INDEPENDENT EXPERT ADVISORY PANEL FOR MINING

REPORT TITLED:

***Metropolitan Coal Mine:
Independent review of environmental
performance to 2022***

Report No: IEAPM 202309-2

Figure 13: Flow data from the Eastern Tributary gauge. Originally Chart 4 in Peabody (2023). (The y-axis scale (mm/day) is the flow volume rate in mm^3/day divided by the catchment area in mm^2 . $1 \text{ mm/day} = 67 \text{ L/s}$.)

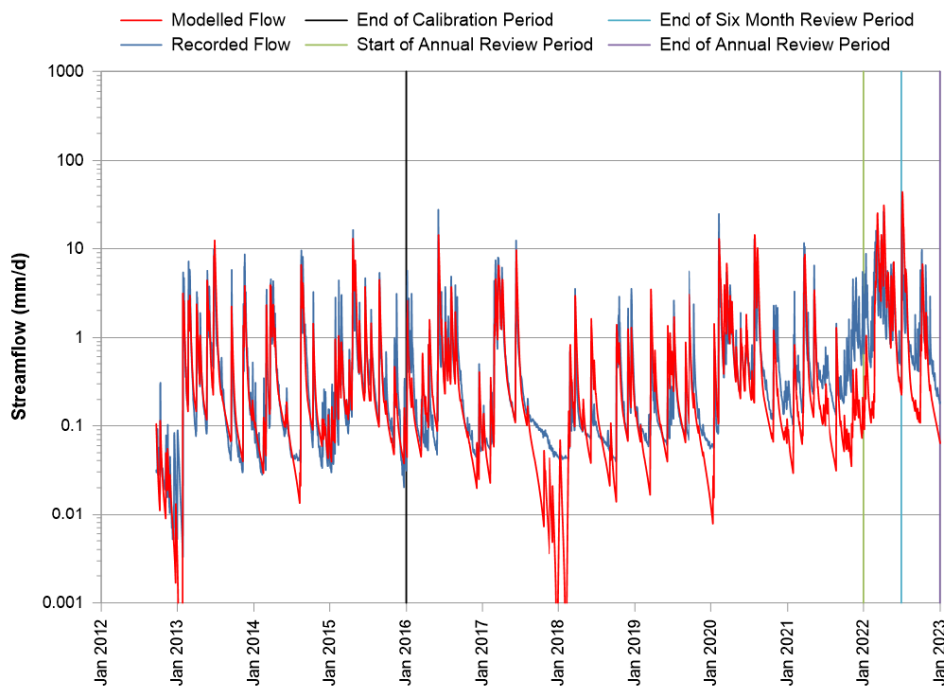
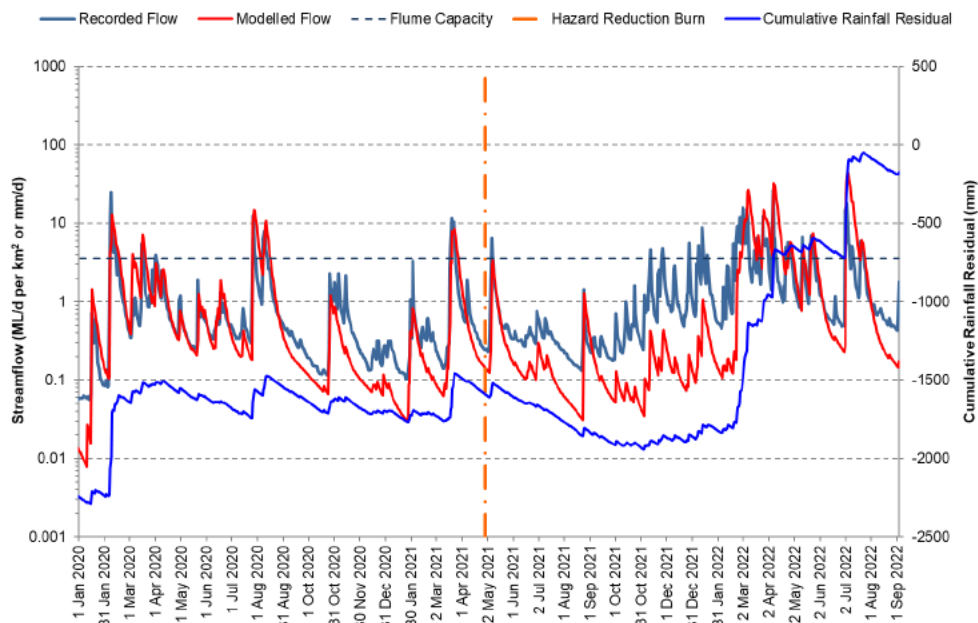
3. The substantially increased flows since August 2020, which is before the burn event, suggest larger volumes of groundwater release following rainfall events. Higher infiltration rates would be reflected in increased interflow volumes and potentially increased regional groundwater levels and discharges. While the AWBM model used to produce the red lines in Figure 13 and Figure 14 will translate high rainfall to groundwater storage and flows, it is possible there are non-linear responses to high rainfall that the model does not account for, which could create the flow anomalies in Figure 13 and Figure 14.

Regarding the timing of the flow anomaly in relation to mining, the clear flow anomaly in Figure 13 and Figure 14 begins in August 2020, whereas mining of LW27 ceased in early 2017, so it seems unlikely that this change in flow response is associated with basal shear plane movement as a result of mining, unless this happened during the 300 longwall series. Predicted valley closure due to cumulative effects of LW302 to LW308 are shown in Figure 10. This shows a small increase in predicted closure from rockbars ETAU to ETAM due to the extraction of LW302 and LW303, being a maximum 25 mm in the vicinity of ETAM. Subsequent longwalls do not result in any increases in predicted valley closure. Where there are closure increments due to LW302 and LW303, it is only in the vicinity of ETAM that the predicted cumulative closure reaches above 125 mm. The Panel concludes it is conceivable but unlikely that ground movements upstream of the Eastern Tributary flow gauge since 2017 were significant enough to increase hydraulic conductivity of shear planes. The Panel recommends that available measurements and predictions of ground movements due to the 300 series of longwalls, including measured valley closures, are reviewed to determine if ground deformation might be responsible for changes in flow responses observed since August 2020.

The unexpected increase in flows that is seen in Figure 13 does not breach the quantity component of the performance measure “*negligible reduction in the quantity and quality of water resources reaching the Woronora Reservoir*” as the flows to the reservoir are higher than expected. The Dupen Report considers long term changes to the flows by suggesting that “*Once a new equilibrium is established, quicker and smaller baseflows may reduce overall flows to the Reservoir*”³⁴ but does not present the basis for this suggestion. The Panel agrees that the pattern of baseflows to Woronora Reservoir would change if the Dupen hypothesis is correct. This is because of the more rapid transit of water through the groundwater system leading to quicker rises and falls in the baseflow component of the reservoir inflows. However, the Panel does not agree with the suggestion that the baseflows would be smaller. The total volume of baseflow would only reduce if groundwater recharge is reduced or if groundwater is diverted out of the reservoir catchment. The Dupen Report identifies higher groundwater recharge conditions as “*stress relief fractures are expected to result in increased infiltration of rainfall runoff from undermined ridge surfaces and soil-rock interfaces*”³⁵. No mechanism is presented in the report that indicates that groundwater is likely to be diverted away from the reservoir catchment. In these circumstances, inflows to the reservoir are not expected to reduce unless the climate changes. This is contrary to Dupen’s assertion.

1. Extension of the Eastern Tributary flow gauge rating curve as recommended in HEC (2022); also spot measurements of flow covering flow rates as high as safely practicable; and urgent repair of the weir. Revised rating curves and the spot measurements of flow should be published in annual reports.
2. Re-analysis of the flow data including the most recent data. This analysis should be of the nature of HEC (2022) but also consider the possibility of increased flows being related to high groundwater or reservoir levels or errors in the modified AWBM model.

Figure 16: Groundwater hydrographs for transect boreholes T1 to T6. (Figures 3 and 4 from SLR, 2023a)

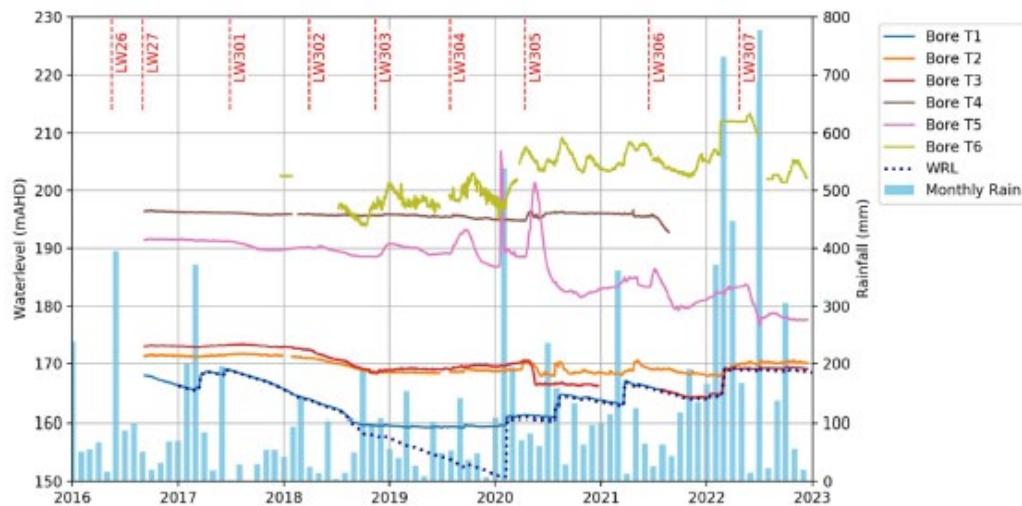
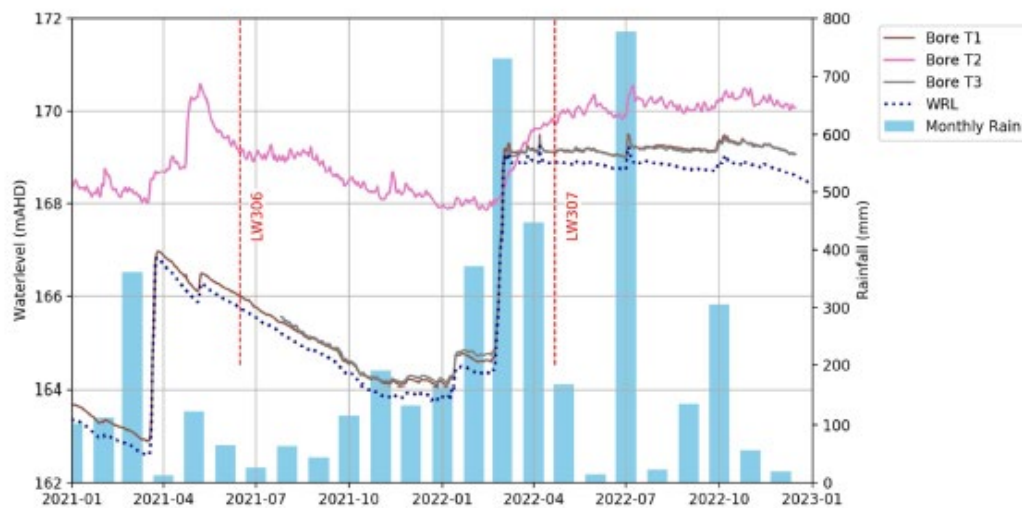
Two of the five transect boreholes (T3R and T1) confirm the intersection of a fracture zone that is hydraulically connected to the Woronora Reservoir. Water levels at these two sites rise and fall with reservoir levels. The latest published trends for all six transect bores are shown in Figure 16.

For the Hawkesbury Sandstone aquifer, there are many monitoring sites at ridgeline locations with multiple depth sensors that show no evidence of aquifer depressurisation or drainage (SLR, 2023b). Many sites show subtle increases in water table levels during recent years as a result of increased rainfall recharge and/or an increase in the Woronora reservoir level. However, the borehole T1 to T5 transect does show some evidence of mining-induced water level declines (Figure 14 in this report taken from SLR, 2023a):

- Water level in Borehole T5 has declined by 10-12 m since the commencement of LW305;
- Water level in Borehole T4 (inoperable since August 2021) declined by approx. 5 m at the commencement of LW306; and
- Water level in the original Borehole T3 declined by approx. 5 m at the commencement of LW305 but has since risen in the deeper replacement bore T3-R with the increase in the reservoir storage levels.
